**APPROVED**  
**MINUTES OF THE MEETING**  
**1 November 2001**

Sand Point/ Magnuson Park  
Arts Plan for Pro Parks Community Center Levy  
Viaduct and Seawall Project

**1 Nov 2001** Project: **Viaduct and Seawall Project**

North Shore Recreation Area (↑)

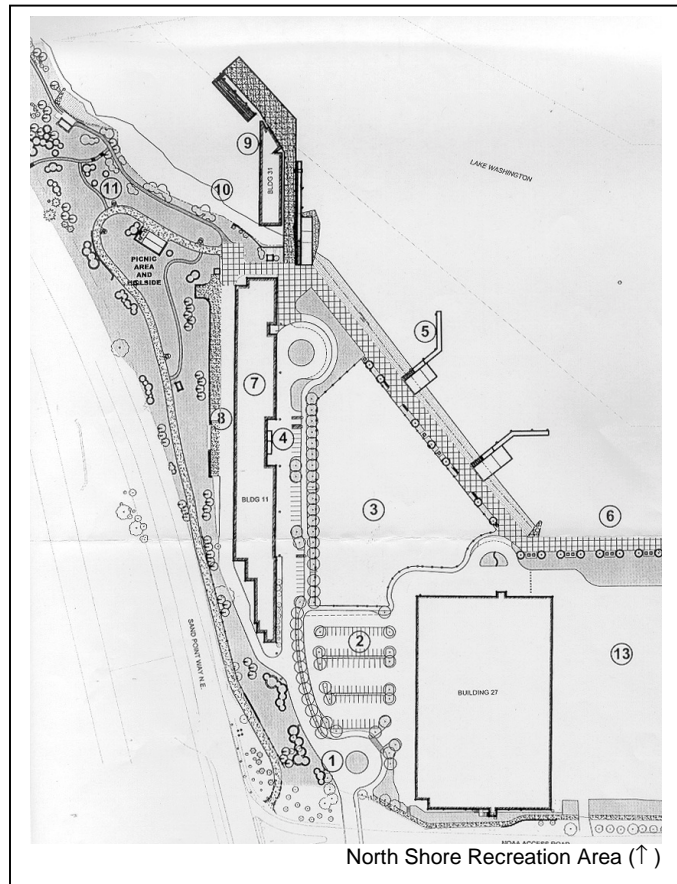
- Would like to know if budget concerns are driving the decision to retain the paved area in the North Shore Recreation Area. Would like to know if there are other alternatives to address these environmental concerns.

- Proponents stated that they are also concerned that, upon removal of the pavement, water permeation would cause contamination of the runoff. Further stated that the contamination levels are above the state level limits. The removal of this contaminated soil could cost millions of dollars. Further stated that, programmatically, this paved surface is preferable as well, to provide storage space and a hard surface around the warehouse storage space. If the paved surface were removed, the removal of the adjacent warehouse storage space would be required as well.

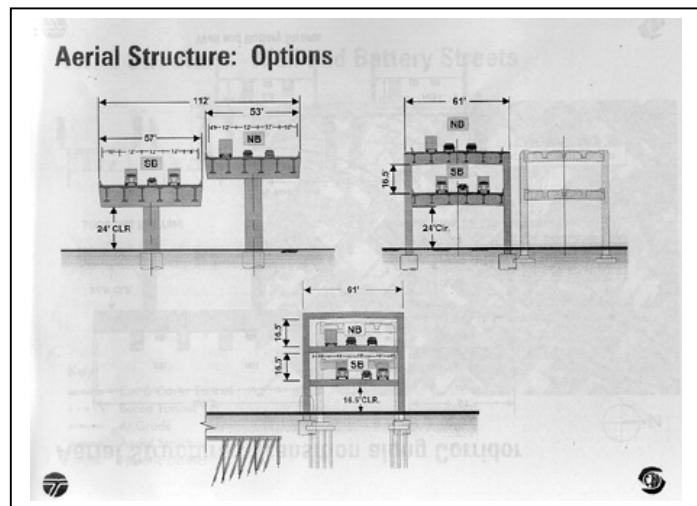
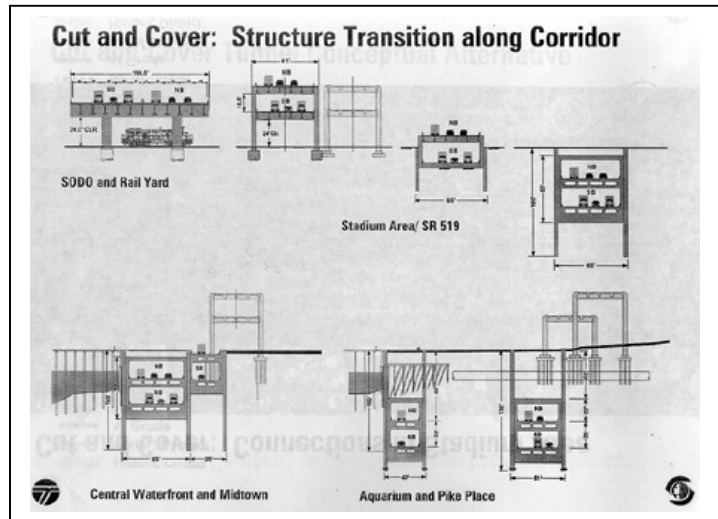
- Believes that access into and out of the midtown areas would be necessary. Believes that the cut and cover concept alternative offers makes good connections to midtown, while the other concept alternative make very difficult connections.

- Cannot imagine the long building that would result if the aerial concept alternative is lidded and enclosed. Is concerned that this long building would block views to the west. Believes that it would be a great barricade between midtown and the waterfront.

- Does not believe that a building created by the aerial concept alternative would be acceptable all along the midtown waterfront, regardless of the design, art, and money used to improve this concept alternative.

- Proponents stated that the bored tunnel concept alternative does not preclude the possibility of midtown connections. The bored tunnel would provide through access, while the boulevard would provide connections to midtown.

- Does not feel that the boulevard is an acceptable alternative. Does not believe that an eight-lane boulevard should be along the waterfront.
  - Proponents stated that, the access provided by the cut and cover and aerial concept alternatives are approximately the same in terms of difficulty.
